## Briefing Note

**To:** DLALC  
**From:** Umwelt  
**Author:** Cormac Farrell  
**Date:** 23 April 2020  
**Subject:** Somersby Planning Proposal Bushfire Constraints – review of revised structure plan for Gateway

**Figure 2.1** Current proposed Development Footprint (Urbis 2019)

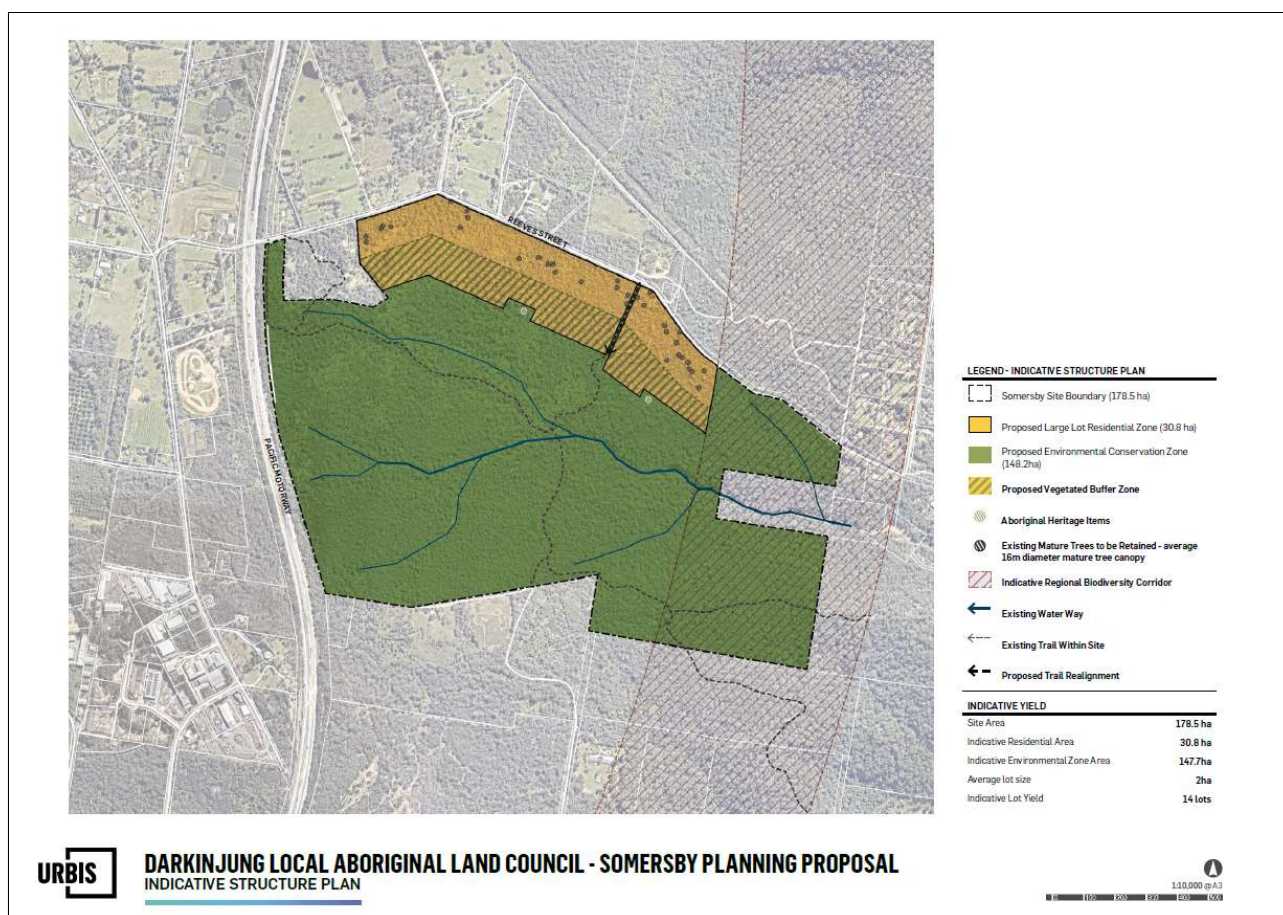
The minimum APZ distances in the preliminary hazard assessment were 37 metres to the south, and 57 metres to the east and west. The difference in the minimum distances is based on a combination of vegetation (fuel) type and slope. The eastern and western ends of the future development area in the proposed Large Lot Residential Zone are the only sections that require an increased APZ distance,

as the future residential land in the middle of the development share the fuel reduced area from adjacent areas.

It is a considered opinion that the APZ for the residential dwellings can be accommodated within the primary disturbance footprint, which is outside of the vegetated buffer shown in the revised structure plan (Figure 1.1). This provides sufficient opportunity to implement these APZ prescriptions and to meet the other aims and performance requirements from RFS without relying on land within the buffer zone.

The APZ requirements as a minimum should prescribe the following:

- Thinning of trees to provide a 3-5 metre separation between the crowns of individual trees
- Removal of most understorey shrubs and branches of trees, with only isolated clumps retained in areas well away from house sites
- Grass and fine surface plants to be mown to <10cm and maintained as such for the duration of the fire season.
